**From:** [Keeven, Leighandra K](#)  
**To:** [Myers, Kevin, EMNRD](#)  
**Subject:** Re: [EXTERNAL] MMD request for comments - Modification 23-1 of HI018EM Lordsburg Playa  
**Date:** Wednesday, September 6, 2023 3:43:25 PM

**RE: Request for Comments on Modification 23-1 of New Minimal Impact Exploration Permit Application, Lordsburg Playa Exploration Project, Permit No. HI018EM, Hidalgo County**

**DATE:** October 6, 2023  
**TO:** Kevin Myers, Hydrologist, Mining Act Reclamation Program (MARP),  
Mining and Minerals Division (MMD), Energy, Minerals and Natural Resources  
Department (EMNRD)  
**THROUGH:** Katie Zemlick, Chief, Hydrology Bureau, Santa Fe, NM *KZ*  
Laura Petronis, Water Resources Manager 1, Hydrology Bureau, Santa Fe, NM *LJP*  
**FROM:** Brad Wolaver, Senior Hydrologist, Hydrology Bureau, Santa Fe, NM *BDW*  
**SUBJECT:** Review of Modification 23-1 of New Minimal Impact Exploration Permit  
Application, Lordsburg Playa Exploration Project, Permit HI018EM, Hidalgo Co.

Review of Modification 23-1 of New Minimal Impact Exploration Permit Application,  
 Lordsburg Playa Exploration Project, Permit No. HI018EM, Hidalgo County

Figure 1. Lordsburg Playa lithium brine exploration project location

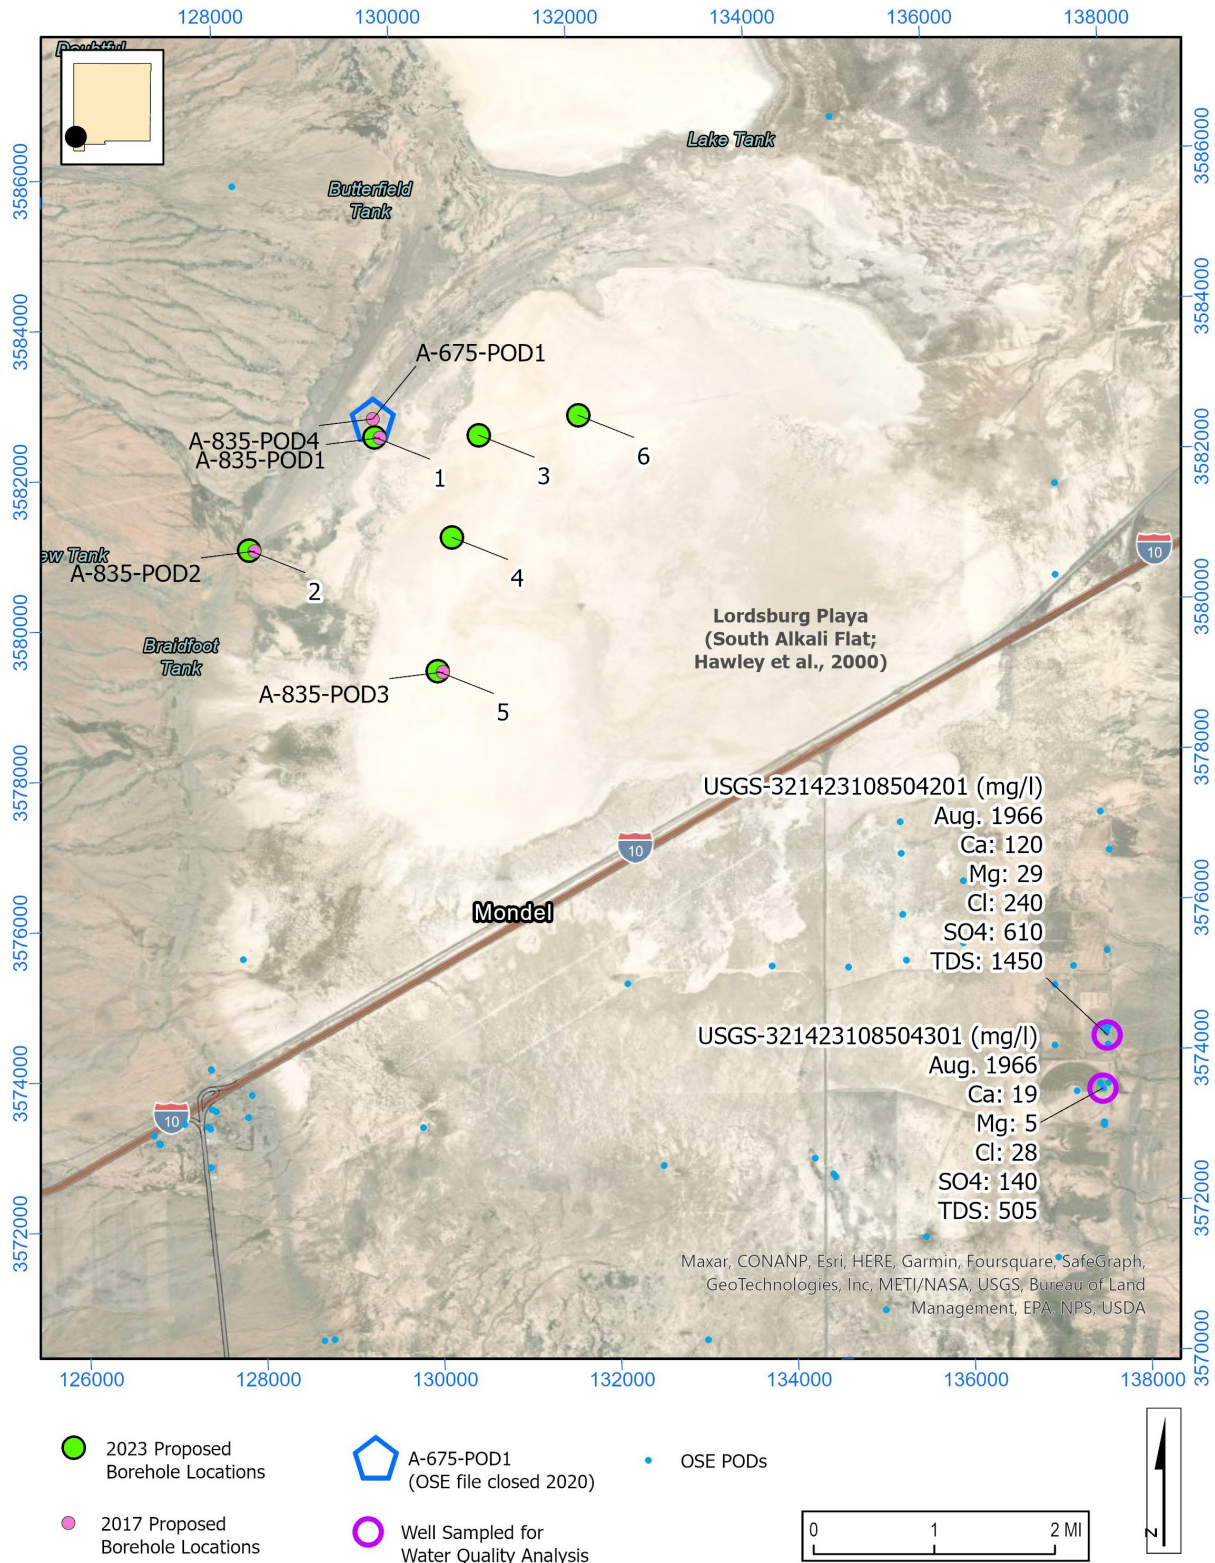
Review comments from OSE hydrologist Doug Rappuhn were provided to MMD permit lead Clinton Chisler on November 20, 2017 (Appendix A). Other agency comments and all documents related to the project are available at EMNRD (2023). The primary concern noted by OSE in the 2017 application was that Section 6 application indicates that the closest well to the proposed boreholes had a sign that said it was a “salt water well not fit for human or livestock use” and had a total dissolved solids (TDS) > 10,000 mg/l (Figure 1, A-675-POD1; TD=150 ft). The

The Hydrology Bureau conducted a review of publicly available hydrogeologic literature for the Lordsburg Playa, to identify potential water quality constituents which may affect the long-term integrity of sealants used in borehole plugging (Hawley J. , 2023; B. J. Hibbs, 2000; McLemore, 2021; Hawley J. , 2023; NWQMC, 2023; Hawley, et al., 2000). The Hydrology Bureau found that boreholes will likely encounter groundwater with elevated sulfate concentration, as the Lordsburg Playa serves as the terminal groundwater discharge site of the Animas Basin. As groundwater moves from the southern end of the Animas Basin to the Lordsburg Playa, gypsum dissolution occurs and groundwater evolves from calcium- and bicarbonate-rich to sodium-sulfate-chloride-rich (Appendix C) (Hawley et al., 2000). At the Lordsburg Playa, evaporative concentration of groundwater occurs, depositing gypsum and halite (Hawley et al., 2000). On the east side of the Lordsburg Playa, two wells drilled in the basin-fill sediments proximal to the playa, approximately six miles southeast of the proposed boreholes, had sulfate concentrations of 140 and 610 mg/l and TDS values of 505 and 1,450 mg/l, respectively (Figure 1). In the immediate vicinity of the proposed project, a well on the west flank of the Lordsburg Playa had a sulfate concentration of 2,600 mg/l (Appendix D; Figure 7-7 of Hawley et al., 2000).

Considering elevated sulfate concentration in groundwater is likely to be encountered in the proposed boreholes, the Hydrology Bureau recommends a sulfate-resistant cement be used during plugging operations (e.g., Type V cement or similar; refer to Table 2 of the Bureau of Reclamation Concrete Manual shown on Figure 2 of BOR, 1988; also refer to Table 2 of ASTM, 1999, which
